Proposal for an amendment to Regulation No 107 (M₂ and M₃ vehicles)

The text reproduced below has been prepared by the expert from the European Commission to provide a specific area in city bus of Class I which would allow the child to remain seated in his pram or pushchair. It supersedes document ECE/TRANS/WP29/GRSG/2010/33 which was submitted by the expert from the European Commission at the 99th Session.

MODEL A

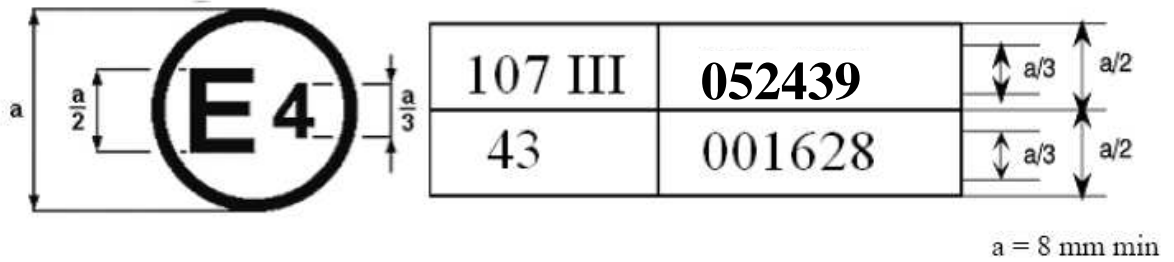
Annex 2, amend to read:

The above approval mark under approval number **052439**. The approval numberas amended by the **05** series of amendments.

Typical dimensions

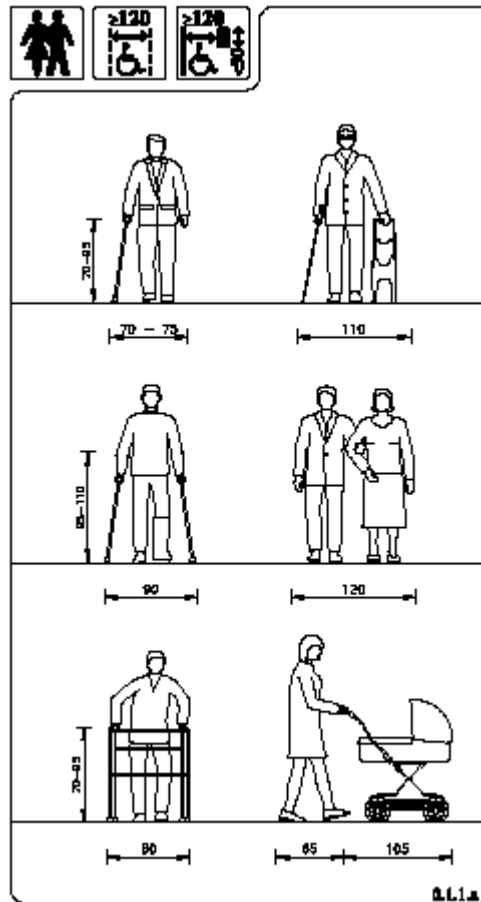
(a) Pram length: 1050 mm

(b) Pushchair length: 875 mm (Chicco lite way) – 850 mm (Maxi-cosi Buzz 3)
